**OMAR N. BRADLEY AIRPORT (MBY)  
CITY OF MOBERLY, MISSOURI**

**MoDOT Project No. 19-034A-1**

**ADDENDUM NO. 1**

**June 1, 2020**

**RUNWAY 13-31 L-861 & L-861E LED (MIRL) EDGE LIGHTS**  
**TAXIWAY L-861T LED (MITL) EDGE LIGHTS**  
**BASE MOUNTED**  
No Scale

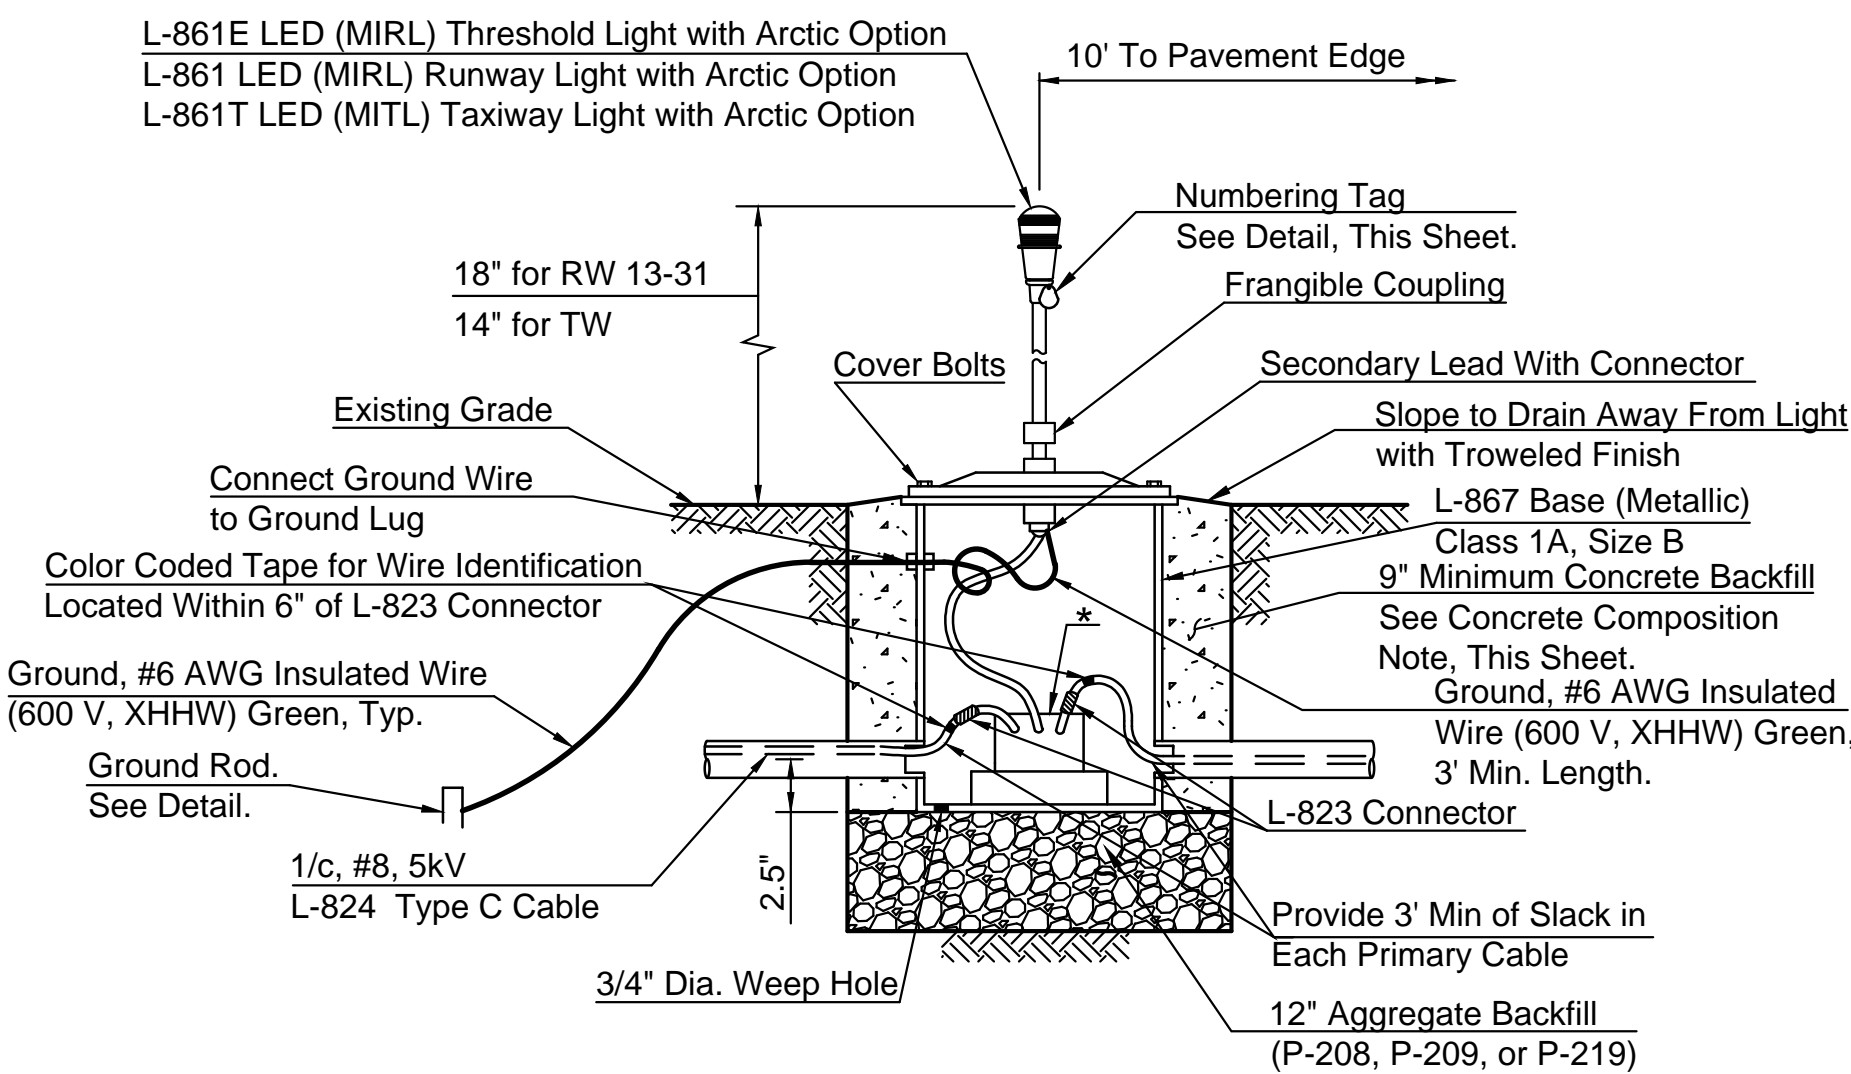
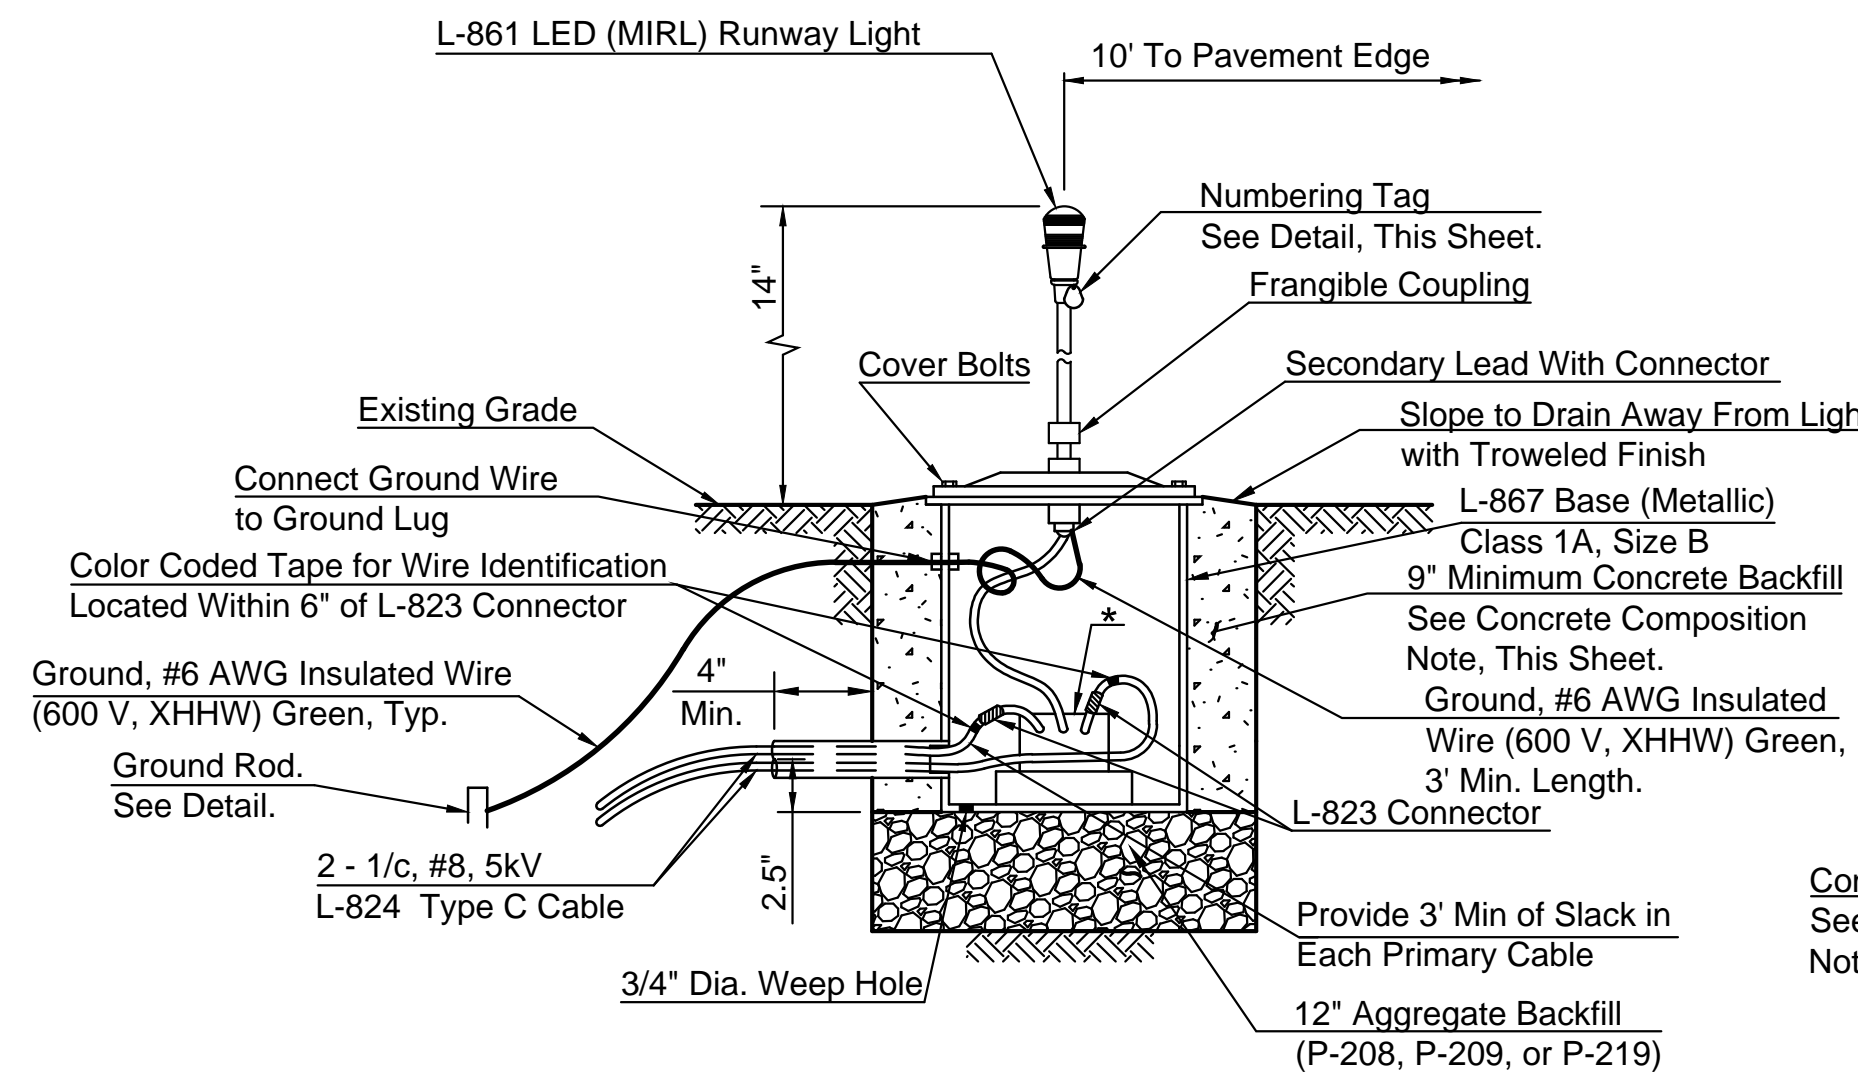
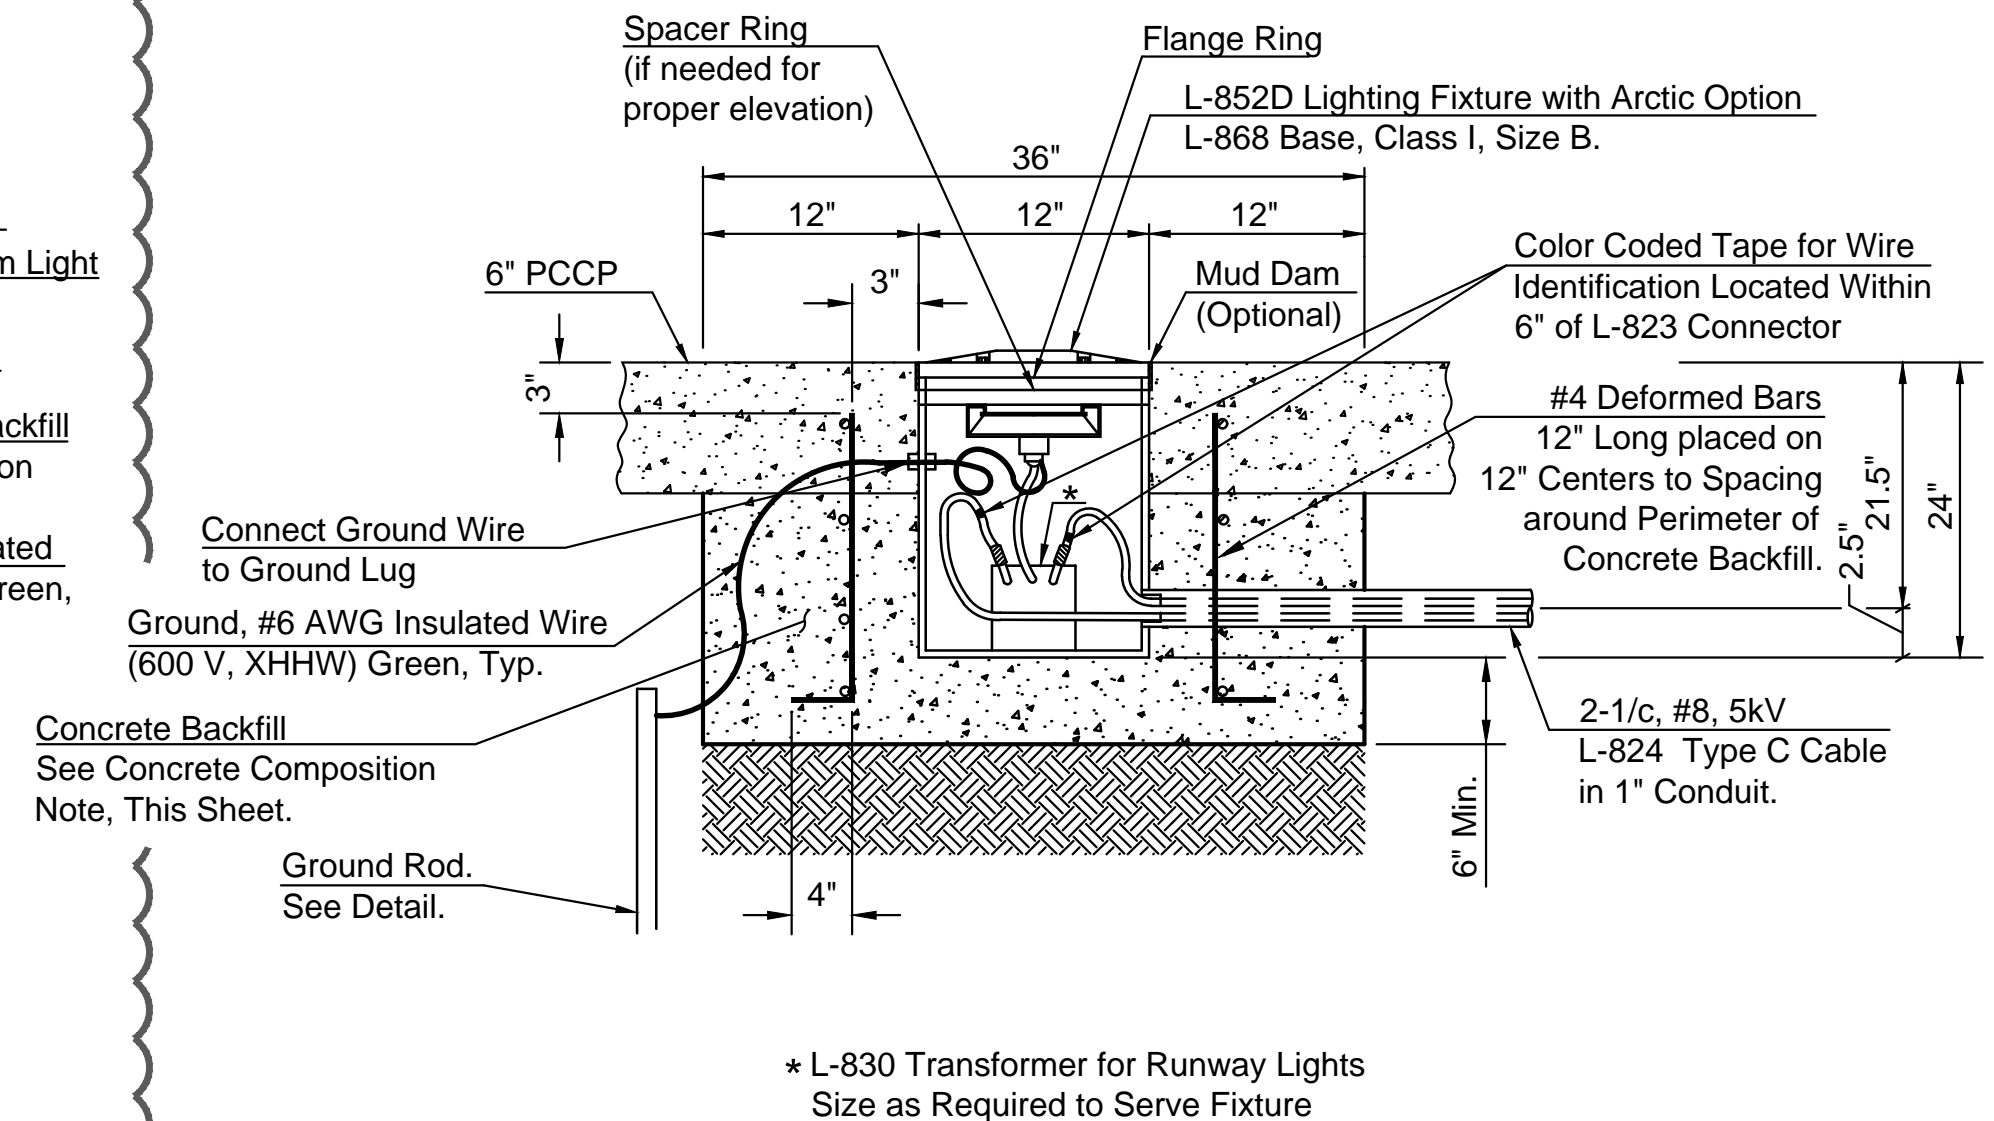
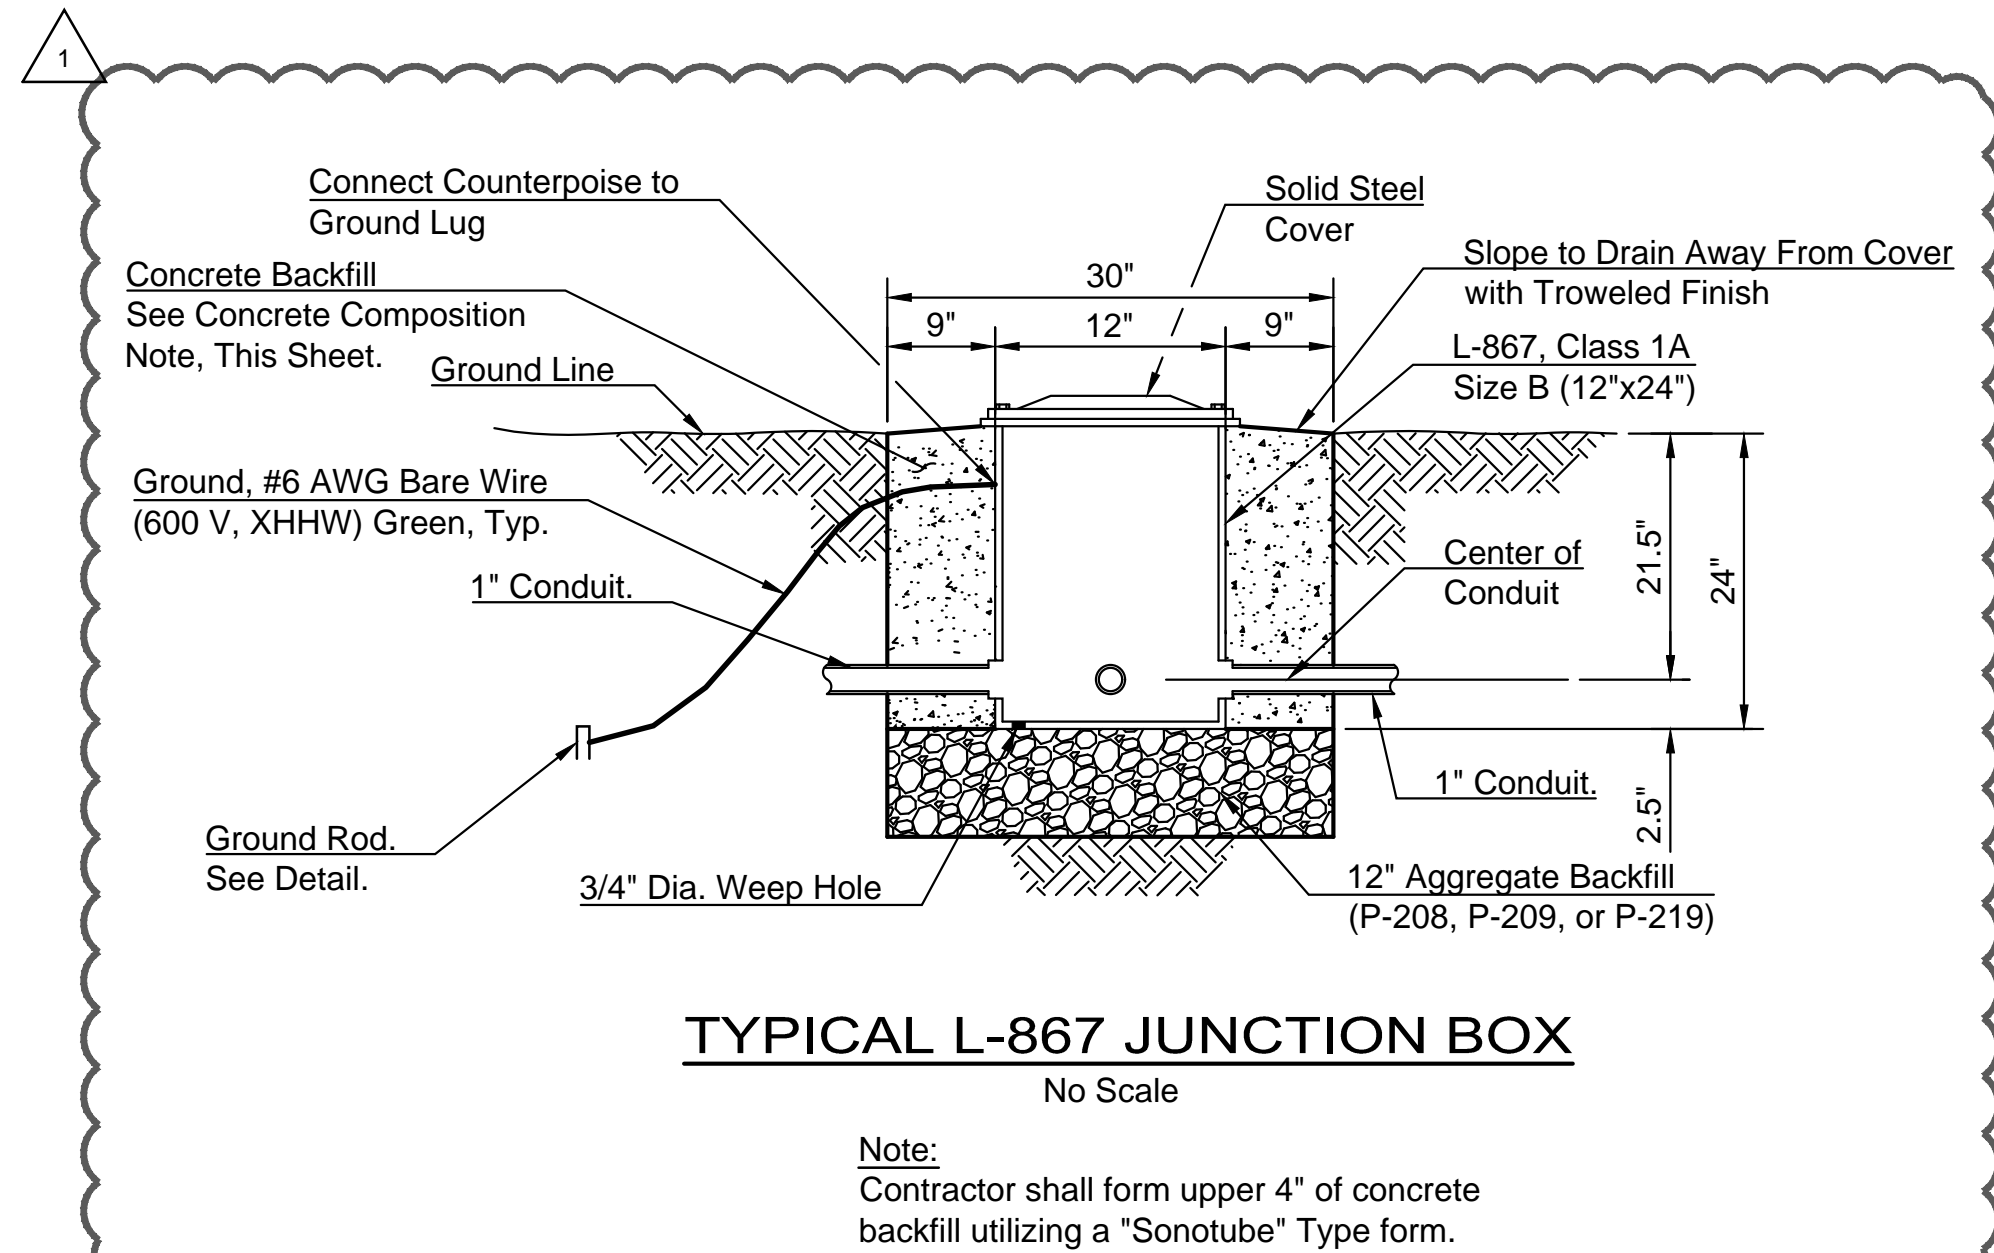
3. Sheet No. 56 Electrical Details. The details depicting base mounted lights and junction boxes have been revised to now reflect a nine-inch thick concrete backfill around the base cans. Additionally, the Contractor is to form the upper 4” of the concrete backfill, provide a troweled finish to the top surface of the concrete backfill, and slope the concrete to drain away from the light.

**Note:**  
Contractor shall form upper 4" of concrete backfill utilizing a "Sonotube" Type form.
